City of Sebastopol Design Review Board Staff Report

June 5, 2019
84
Design Review Board
Dana Morrison, Assistant Planner
Design Review Amendment- Minor landscaping, lighting, and building design changes
Approval with Conditions
Piazza Hospitality Group / Bella Commercial Management, LLC/Marigold LLC
6828/6826/6824 Depot Street and 215/225 Brown Street
Mitigated Negative Declaration
Central Core
CD: Downtown Core

DESIGN REVIEW AMENDMENT: Minor changes to: eastern (massing) and southern (balconies + additional maker's space) building design, courtyard landscape features, and lighting plan File: 2016-57 and 2018-86 6828, 6236, 6824 Depot Street Hotel Sebastopol- Mixed Use

Plan Check Response Letter – DRB Items

B-K LIGHTING	40429 Brickyard Drive • Madera, C. 559.438.5800 • FAX 559.43 www.bklighting.com • info@bkl	8.5900	RELEASED 05-17-17	DRAWING NUMBER SUB-2273-00
Hiram Banks	Sebastopol Hotel	Project #: 184-17	Date:	04.15.19	TYPE
Lighting	LIGHTING FIXTURE CUTSHEET	Issue: PERMIT SET	Γ		F13

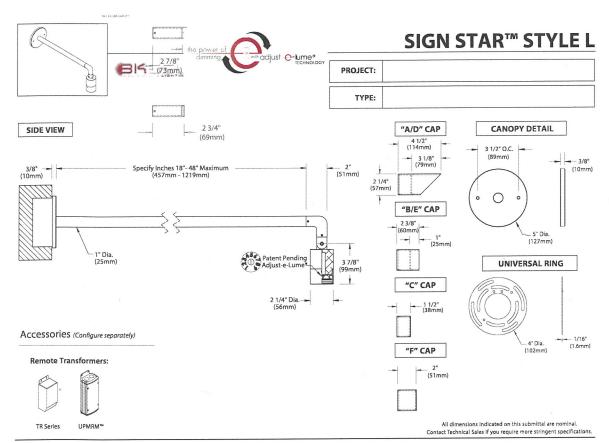
- F13 lighting surface mounted flood lights at the restaurant, Depot street frontage. Are these wall washes?
 F13 fixtures are downward facing, sign lights to light the entry doors to the restaurant and artist/maker spaces. See LP2.0A, LP2.0B, and F13 cutsheets.

- *ii. F13:* These fixtures are downward facing, sign lights to light the entry doors to the restaurant and artist/maker spaces. See LP2.0A, LP2.0B, and F13 cutsheets.

LIGHTING FIXTURE CUTSHEET Issue: PERMIT SET F38

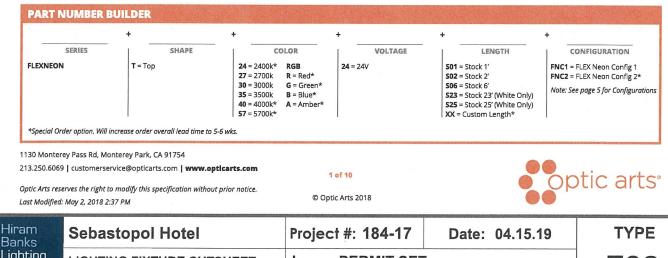
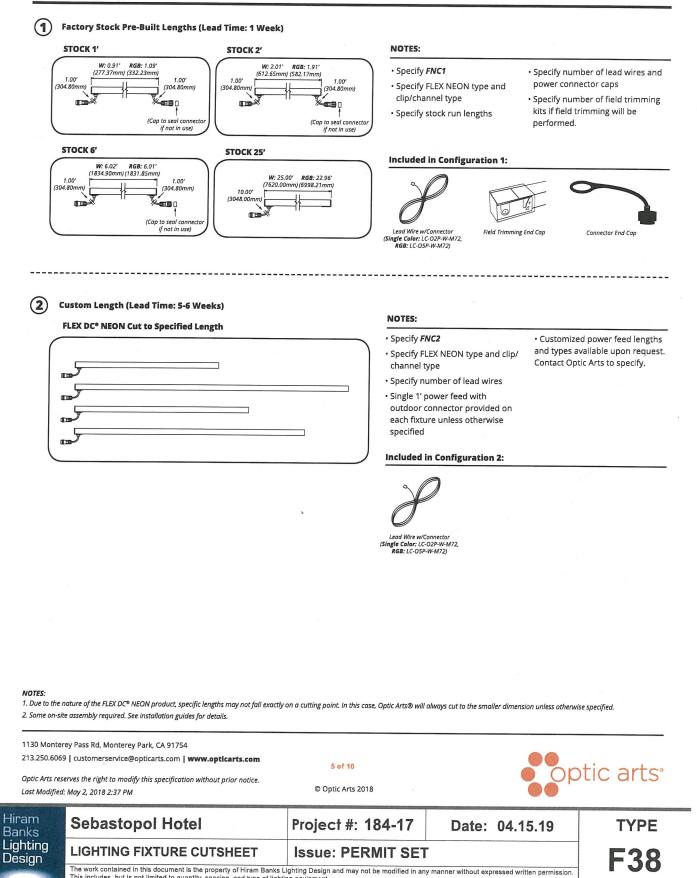
- F38 lighting fixture, Suite 24 deck, Brown Street.
 F38 fixtures are LED tapelights in the level 2 guardrail, facing downward to light the decking surface and wash the guardrails. See LP3.0A and F38 cutsheets.

- vi. *F38*: These fixtures are LED tapelights in the level 2 guardrail, facing downward to light the decking surface and wash the guardrails. See LP3.0A and F38 cutsheets.

Hiram Banks	Sebastopol Hotel	Project #: 184-17	Date: 04.15.19	TYPE
Lighting Design	LIGHTING FIXTURE CUTSHEET	Issue: PERMIT SET		F43
	The work contained in this document is the property of Hiram Banks L This includes, but is not limited to quantity, spacing, and type of lighti	F43

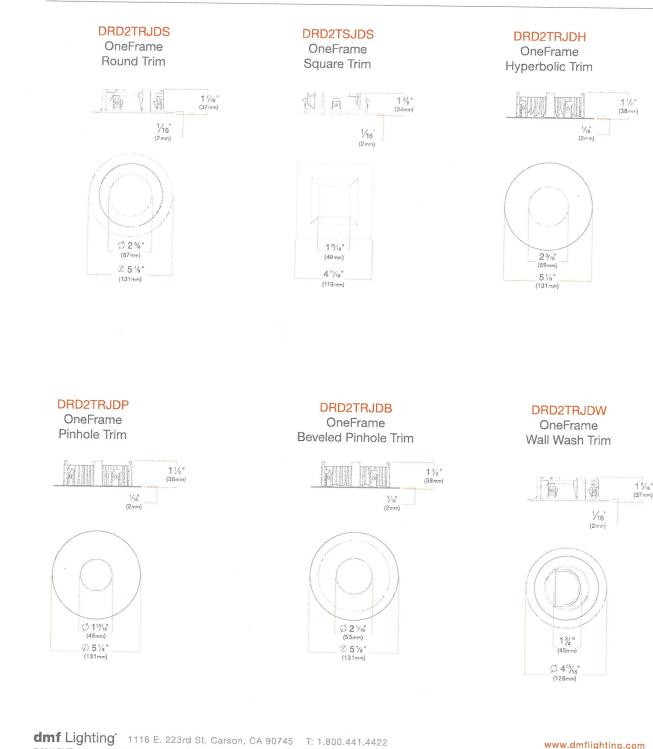
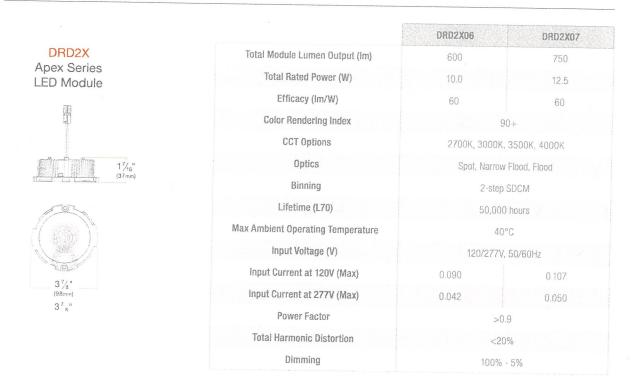
- 10. F42 lighting fixture Brown Street northeast. F42 fixtures are wall-recessed step lights for accessible ramps. See LP2.0A and F42 cutsheets.
- F43 lighting fixture, along Petaluma Ave.
 F43 fixtures are soffit-recessed downlights for retail storefronts. See LP2.0B and F43 cutsheets.

- iv. *F-42:* These fixtures are wall-recessed step lights for accessible ramps. See LP2.0A and F42 cutsheets.
- v. *F43:* These fixtures are soffit-recessed downlights for retail storefronts. See LP2.0B and F43 cutsheets.

david baker architects dbarchitect.com 461 second street loft 127 san francisco california 94107 v.415.896.6700 f.415.896.6103 Floor Plan - Level 2

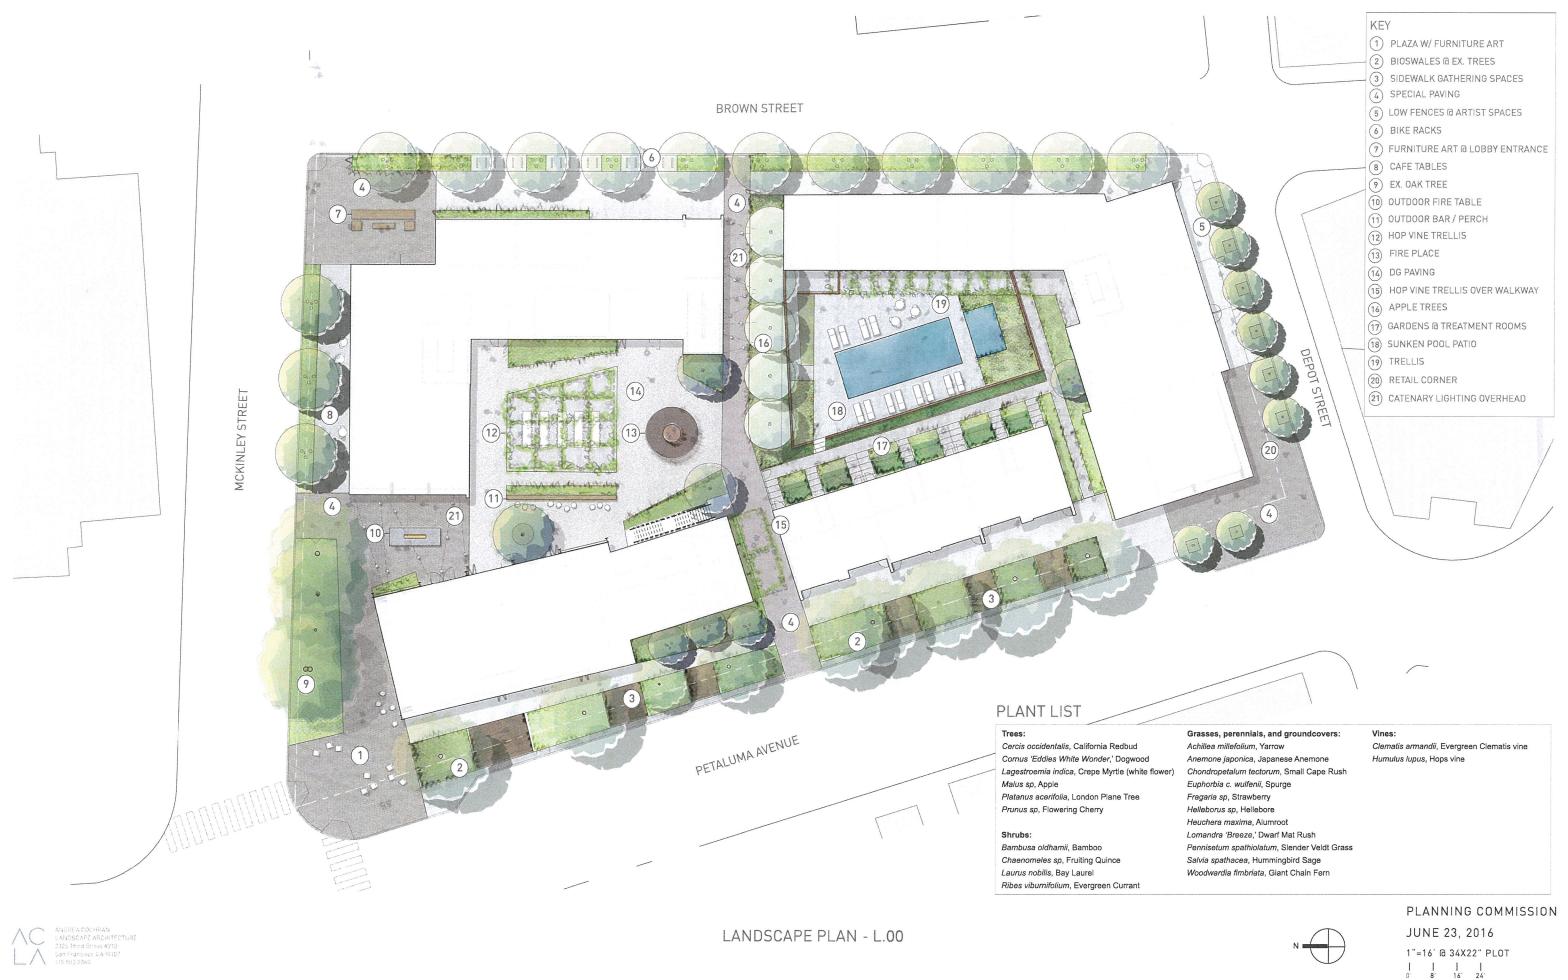
- New balconies on hostel rooms sw corner of bldg. (Depot St façade) Yes, balconies were added to the hostel rooms to equalize amenities for all room types. See A120B and 1/A200.

- 4. *Balconies:* According to the applicant, balconies were added to the hostel rooms to equalize amenities for all room types. The proposed design matches the existing balconies approved and located throughout the rest of the complex. See A120B and 1/A200

L1.01

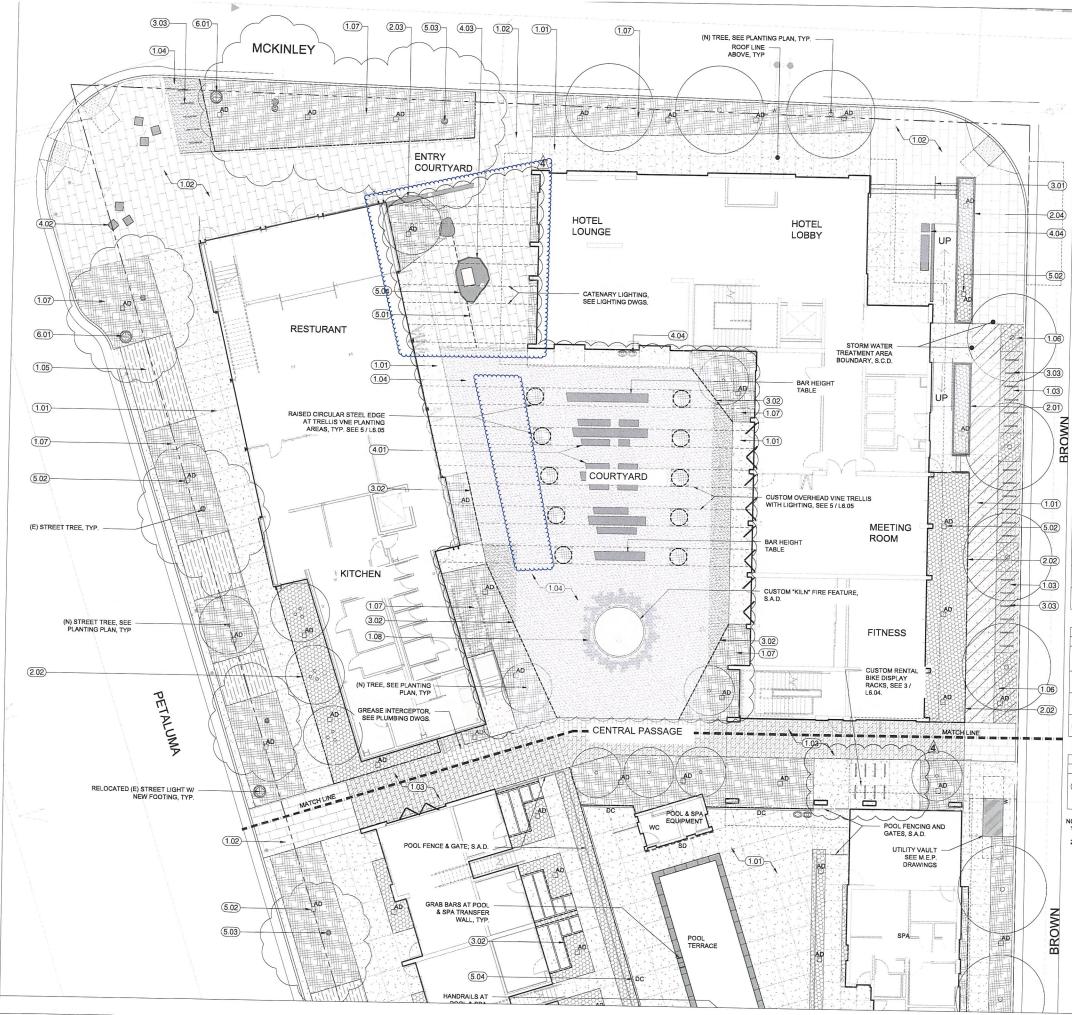
- 4. A number of outdoor/courtyard elements have been revised, including:
 - a. New water feature at northwest courtyard entry, The entitlement set showed an "outdoor fire table". We are now showing a custom water feature that is built out of a local, hollowed-out boulder. Given that we already have a fire-feature in the courtyard, we felt that a water feature at the courtyard entry would be more appropriate. See L1.01 and 1, 2/L6.05.

The "outdoor bar/perch" shown on the entitlement set blocked views from the open restaurant to the courtyard, so it was deleted. We added a concrete bench wall at the courtyard entry to serve as a retaining wall to solve grade elevation issues that we found during design development. See L1.01 and 9/L6.04.

- c. Unidentified element (between Entry courtyard bench and water feature (boulder?) Yes, that item is another boulder.
- NE quadrant of building has been lengthened by 8' (86' to 94' and open space gap reduced from 30' to 23'...Functionally, this means several Jr Suites became full suites. Yes, that is correct. This was done on request of the owner based on market research for guest room mix. Two stacks of Junior Suites became Suites. See A120A.

- 2. Courtyard changes
 - i. *New water feature:* The entitlement set showed an "outdoor fire table". Plans now show a custom water feature that is built out of a local, hollowed-out boulder. According to the applicant, given that there is already a fire-feature in the courtyard, they felt that a water feature at the courtyard entry would be more appropriate. See L1.01 and 1, 2/L6.05.

- *ii.* Different bench: According to the applicant, the "outdoor bar/perch" shown on the entitlement set blocked views from the open restaurant to the courtyard, so it was deleted. The applicant added a concrete bench wall at the courtyard entry to serve as a retaining wall to solve grade elevation issues that were found during design development. See L1.01 and 9/L6.04.

- *iii. Unidentified element:* This item is a boulder.
- 3. Lengthening of NE section of building: According to the applicant, this was done at the request of the owner based on market research for guest room mix. This change allowed for two stacks of Junior Suites to become Suites. See A120A
